CHANGES TO BASE PRODUCT AC-020 (2590A) TO AC-020(10M) (5964)

Assembly Pl Approval W. WU	Approved by B. CHILDS	Checked by W. SINDEN	Drawn by A.FOSTER
Angle of Projection 	Units mm	Scale N/A	Released 29/11/19
Status RELEASED	Part No 5964	AC-020(10M)	
		BE-004253-00-19

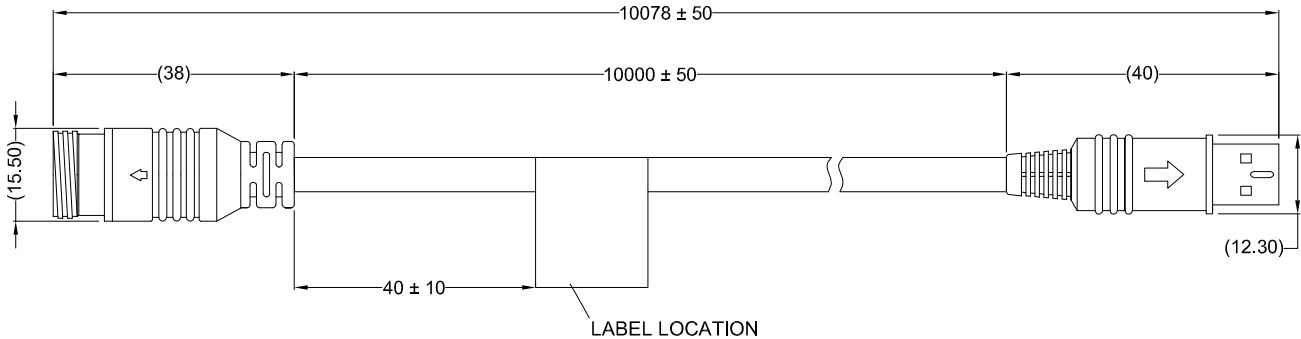
- CHANGE:
1. CABLE LENGTH INCREASED FROM 640±30MM TO 10000±50MM
 2. CABLE LABLE CHANGED FROM AC-020 CBL-LBL TO AC-020(10M) CBL-LBL
 3. GIFTBOX LABLE CHANGED FROM AC-020 GB-LBL TO AC-020(10M) GB-LBL
